有關的規劃申請編號 The application no. to which the comment relates Y/1-DB/2

Area 6f, Lot 385 RP & Ext (Part) in D.D. 352, Discovery Bay

To rezone the application site from "Other Specified Uses" annotated
"Staff Quarters (5)" to "Residential (Group C) 12"
(Y/I-DB/2)

申請編號 Application No. Y/I-DB/2
此頁摘自申請人提交的文件。
This page is extracted from applicant's submitted documents.

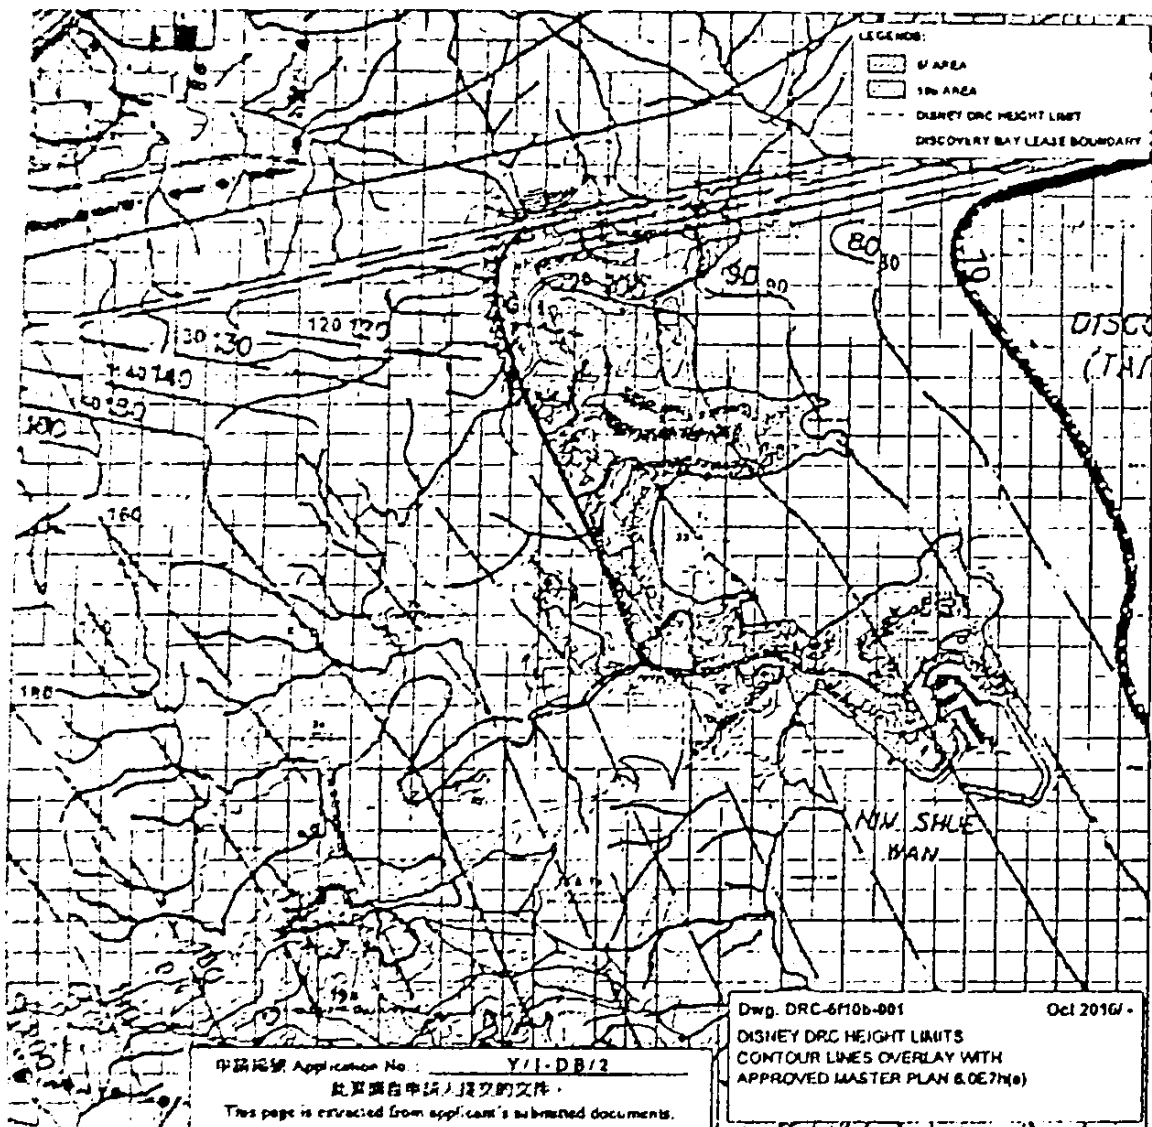
b. Figure B.9 view from DB Plaza – these poor quality photomontages hardly reflect the views from the Plaza on a clear day as illustrated in the VOC photos in Annex 1 to this submission.

PVOC;
These poor quality
Photo-montages hardly
reflect the views from the
Plaza on a clear day - see
attached.

AREA 6f
PROPOSED RESIDENTIAL DEVELOPMENT

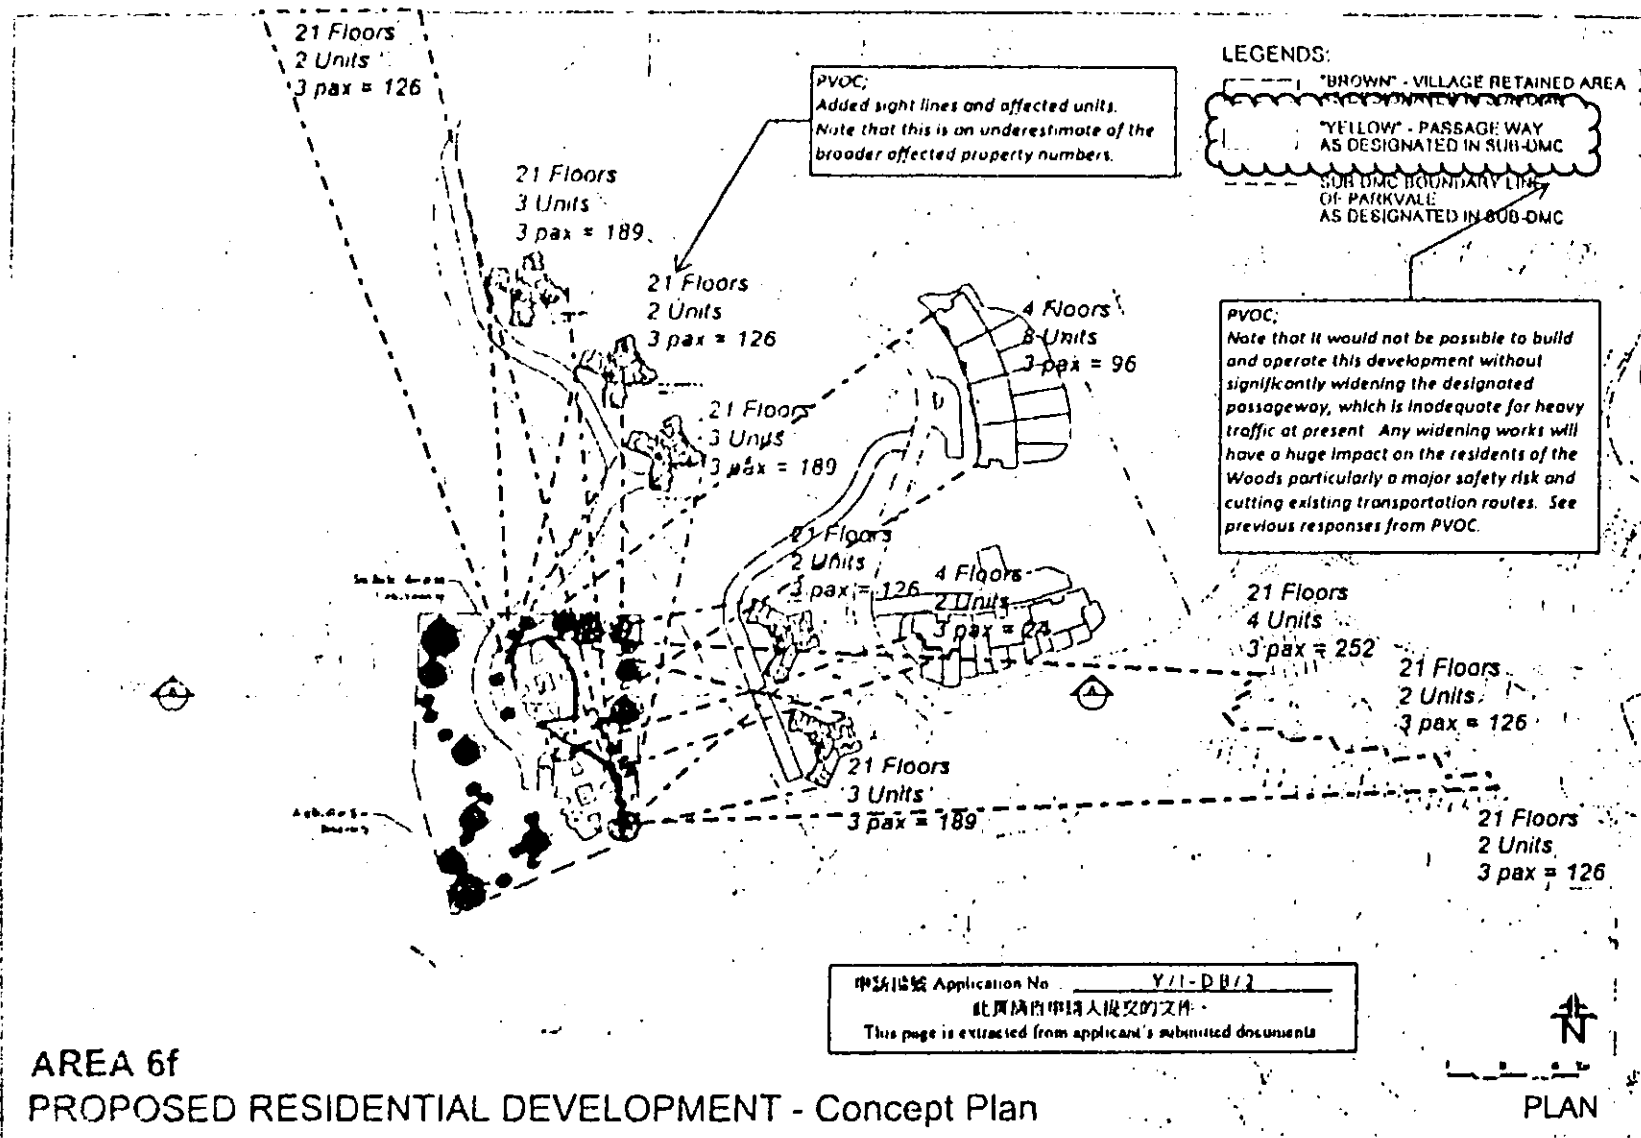
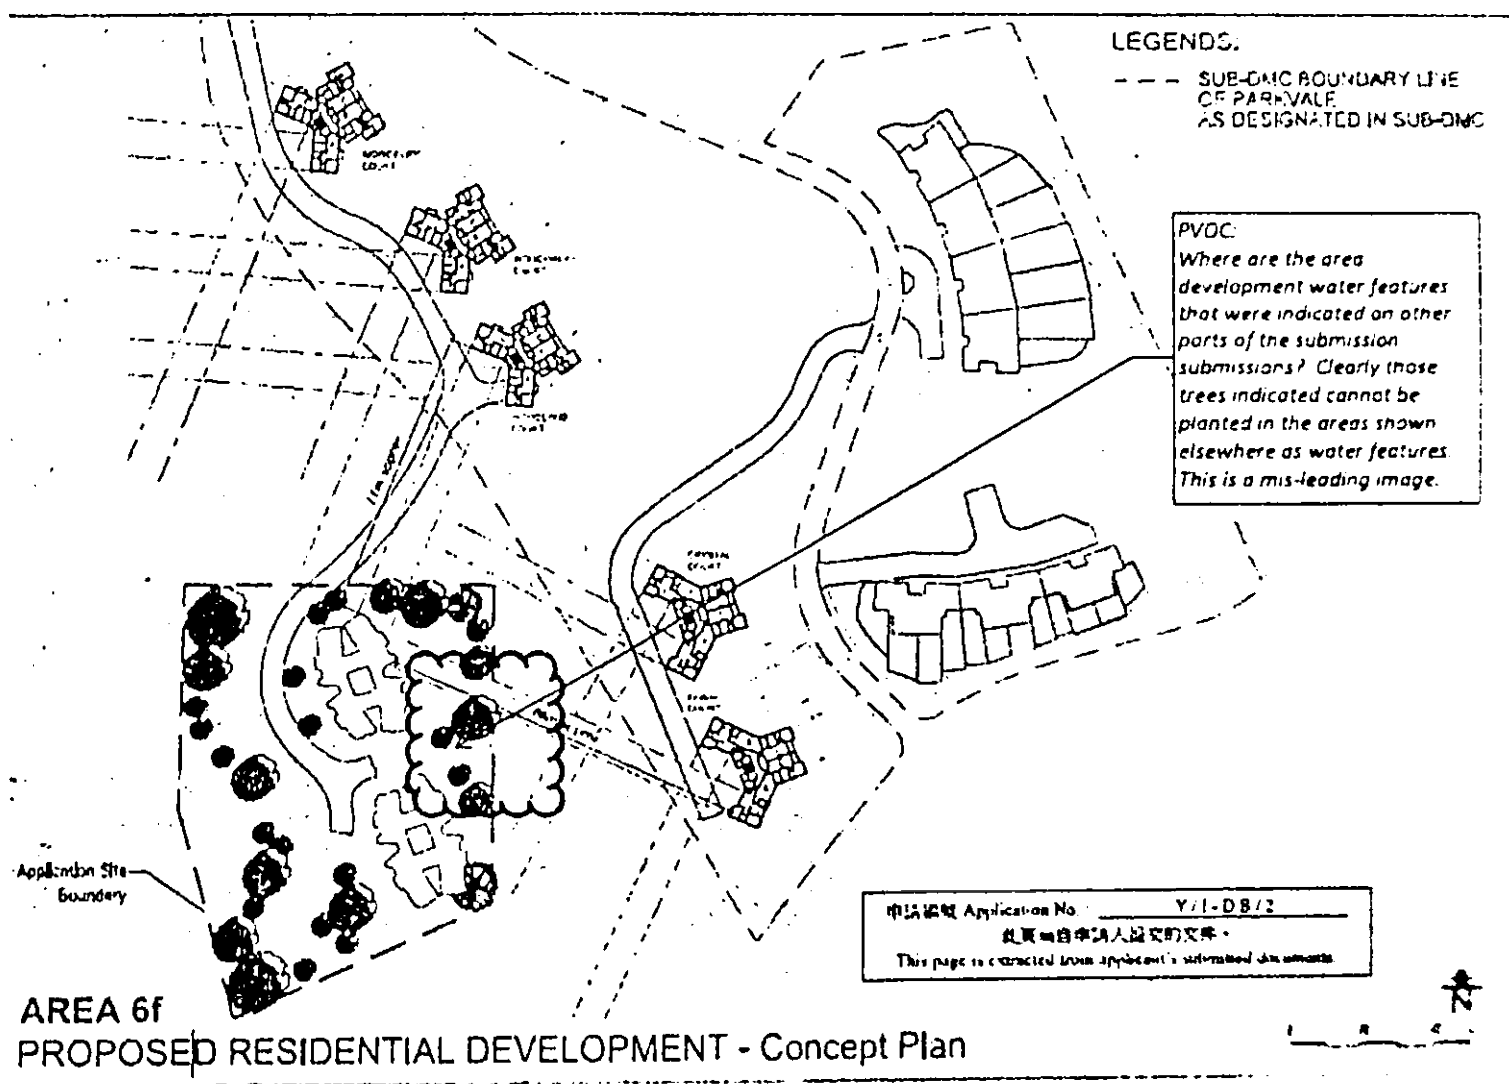
b. Optimisation of land use figure B.2. This figure includes incorrect statements about the existing slopes since the existing slope does not match the profile indicated by HKR's consultant: the existing slope profile shown in the figure does not reflect the correct levels as per the Lands Department Survey; the existing ground condition shown in the figure is incorrect since it does not match the Lands Department Survey data for this area. Furthermore, there is no account for the road or for the slope that exists at the rear of Crystal Court.

This existing ground condition is incorrect. It does not match the HK Lands Department Survey Data for this area. There is no account for the road or for the slope that exists at the rear of Crystal Court.

<p>SECTION A-A</p> <p>DISCOVERY BAY OPTIMIZATION OF LAND USE - AREA 6F</p>	<p>PVOC; Existing does not match the profile indicated by the consultant.</p>	<p>FIGURE: B.2</p>
--	---	---	------------------------

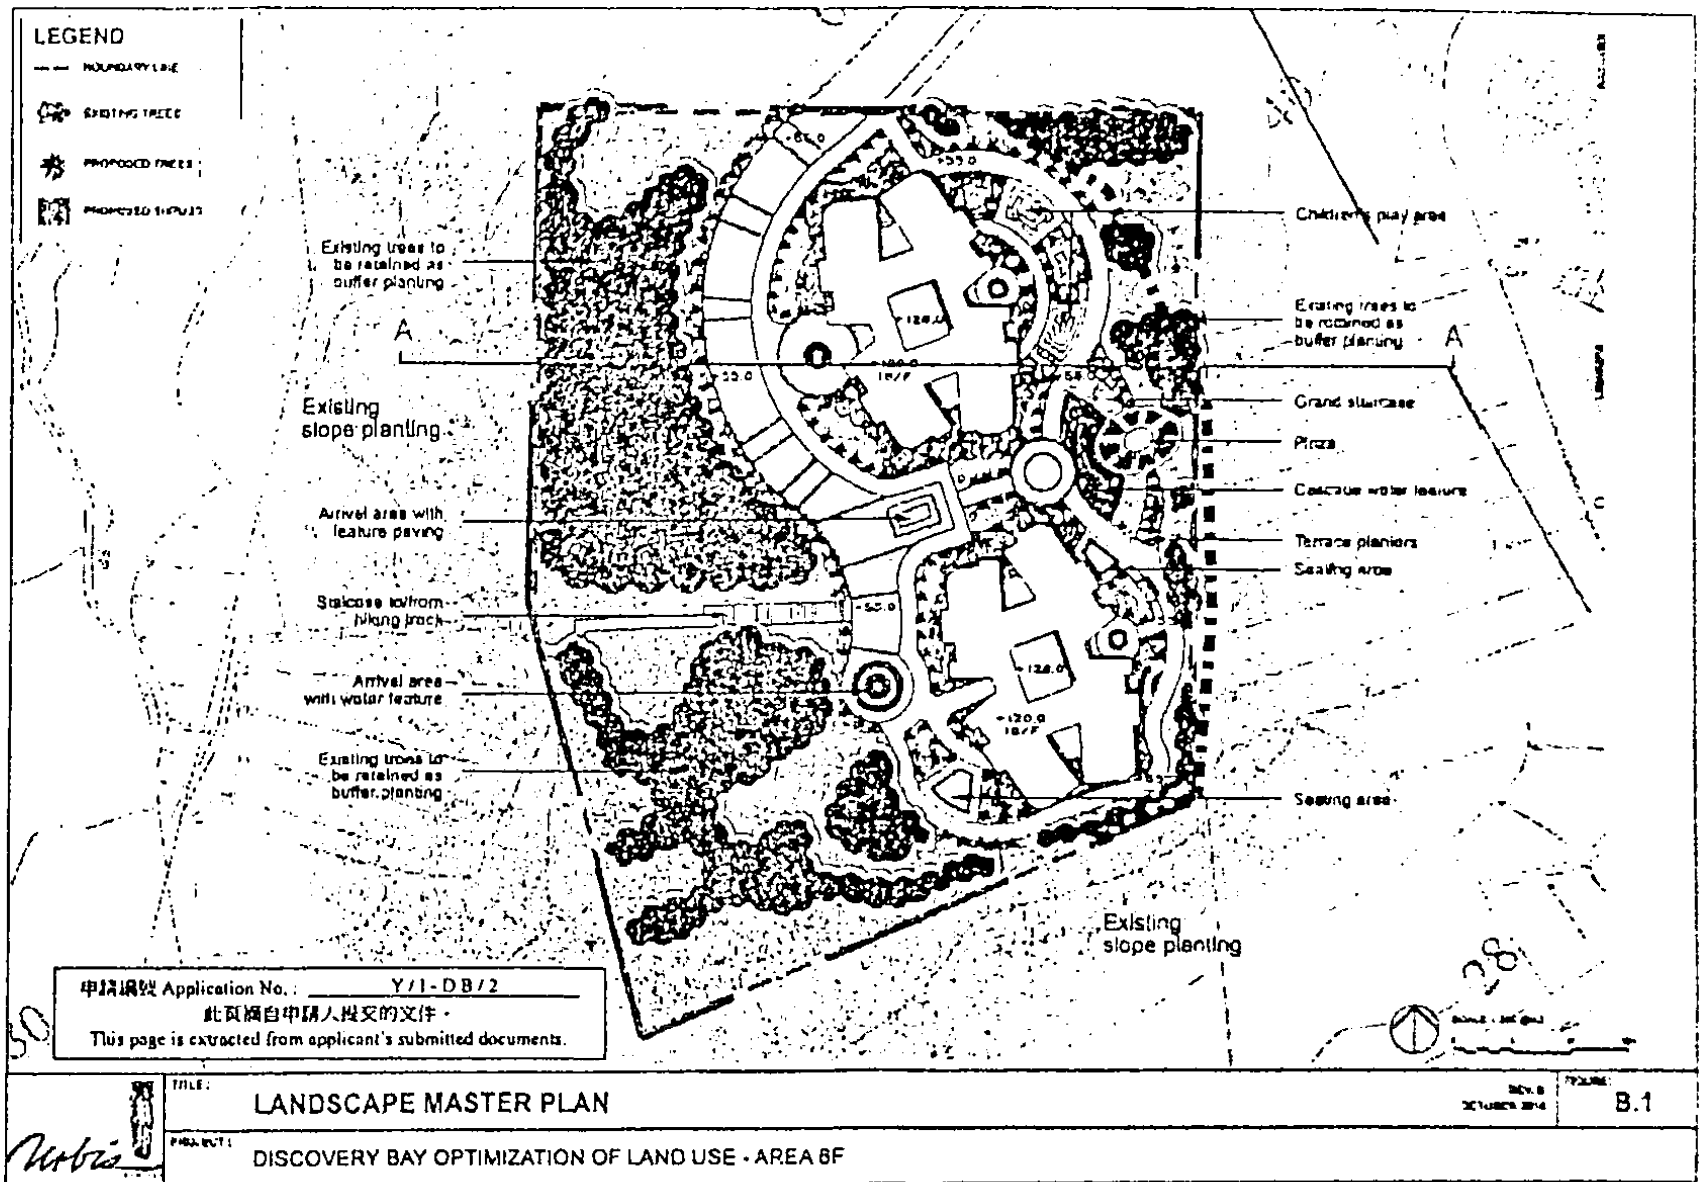
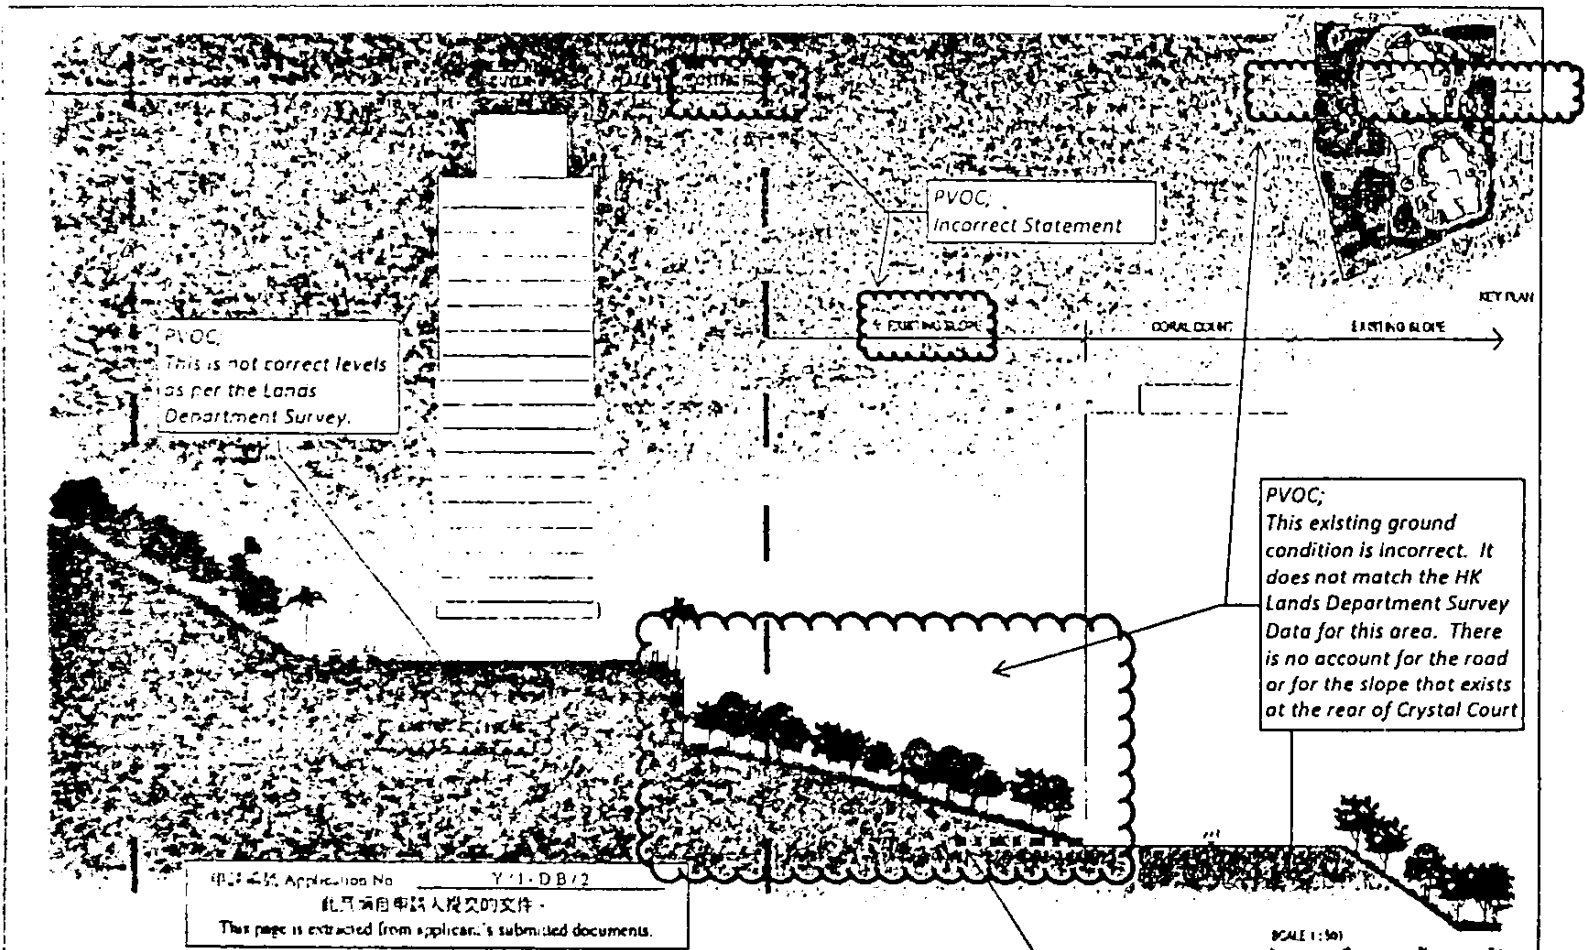
- b. Optimisation of land use figure B.2. This figure includes incorrect statements about the existing slopes since the existing slope does not match the profile indicated by HKR's consultant: the existing slope profile shown in the figure does not reflect the correct levels as per the Lands Department Survey; the existing ground condition shown in the figure is incorrect since it does not match the Lands Department Survey data for this area. Furthermore, there is no account for the road or for the slope that exists at the rear of Crystal Court.

申請編號 Application No.: Y/1-DB/2
此頁摘自申請人提交的文件。
This page is extracted from applicant's submitted documents.

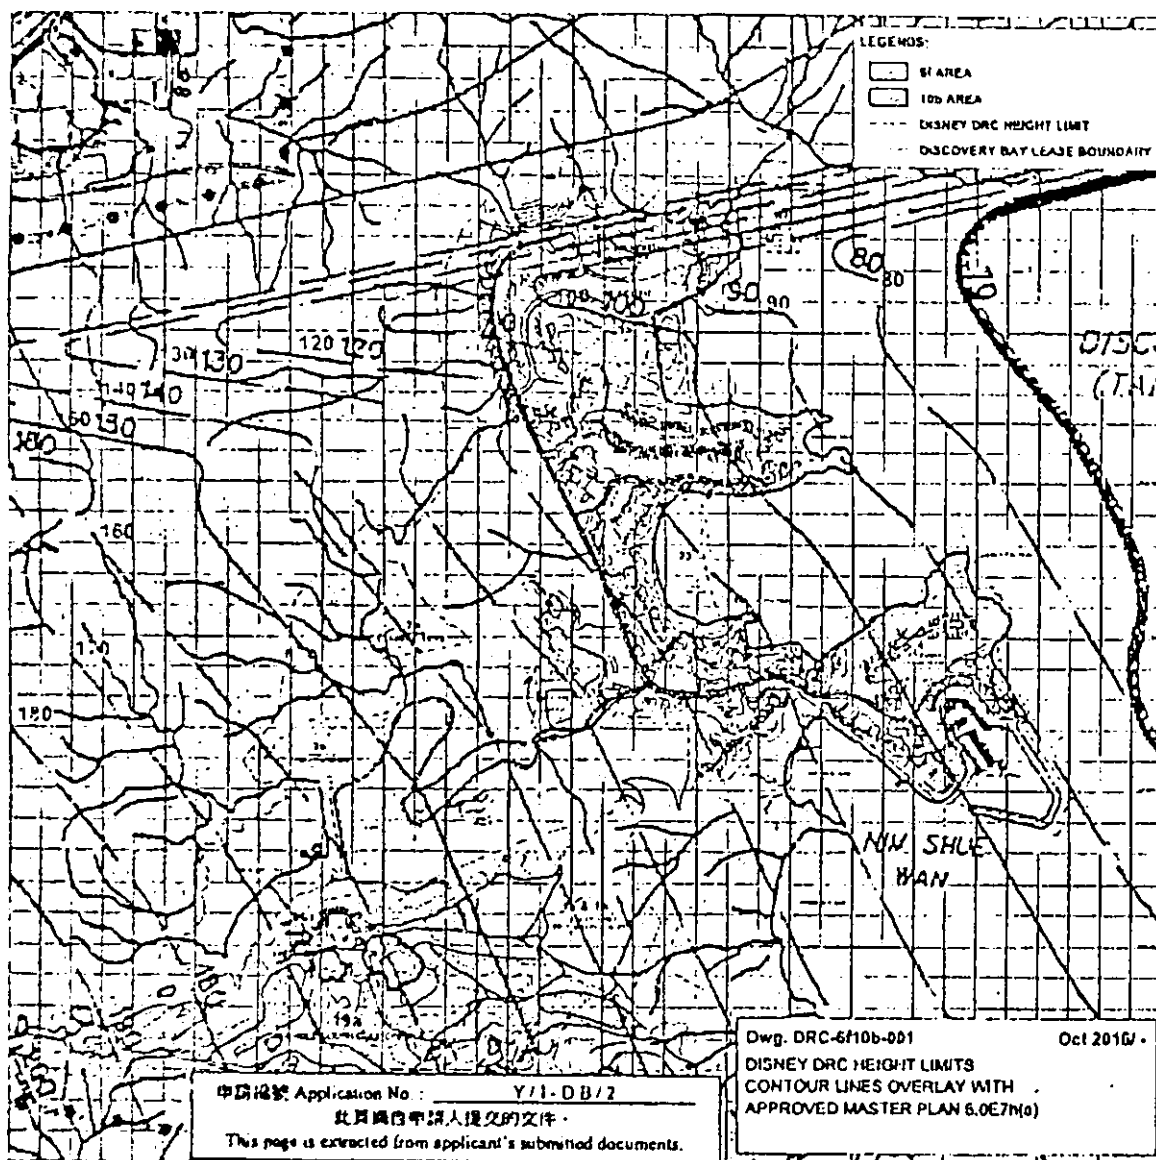
PVOC;
*These poor quality
 Photo-montages hardly
 reflect the views from the
 Plaza on a clear day - see
 attached*

- b. Figure B.9 view from DB Plaza – these poor quality photomontages hardly reflect the views from the Plaza on a clear day as illustrated in the VOC photos in Annex 1 to this submission.
